Technical Bulletin / Safety Alert

Unique ID No: GEN2010-TBSA-03 Rev: 1

Subject: JUG-A-0 UL/UV Pneumatic Horn Circuit

Applicable to: All JUG-A-0 UL/UV V2 & V3 machines.

Figure 1: Revised Pneumatic Horn Circuit

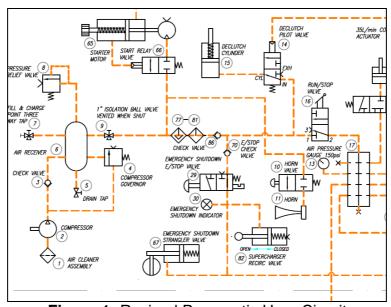
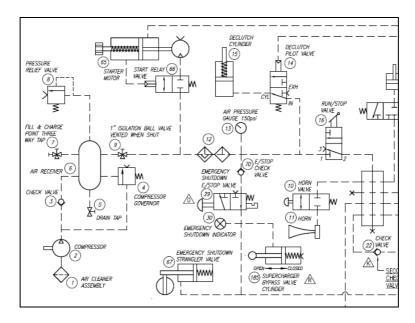
Investigation of the occurrence described above identified that the rate of air delivery to the circuit containing the horn valve and horn was insufficient to replenish the air being exhausted by the horn, when the horn valve was activated continuously for extended periods. In this case, air pressure in the circuit was able to reduce to less than 60psi, which was the minimum pilot pressure required for the park brake valves.

It is recommended the pneumatic horn circuit is separated from the pneumatic circuit and installed as per the revised schematic shown in Figure 1 below. Figure 2 shows the original installation schematic. The complete revised pneumatic schematic is also attached.

A one way check valve (part no. 0601-60008) has also been installed in the safety circuit and the air pressure gauge source relocated. The check valve is located after the filter / drain / lubricator. The air pressure gauge is now sourced from the manifold.
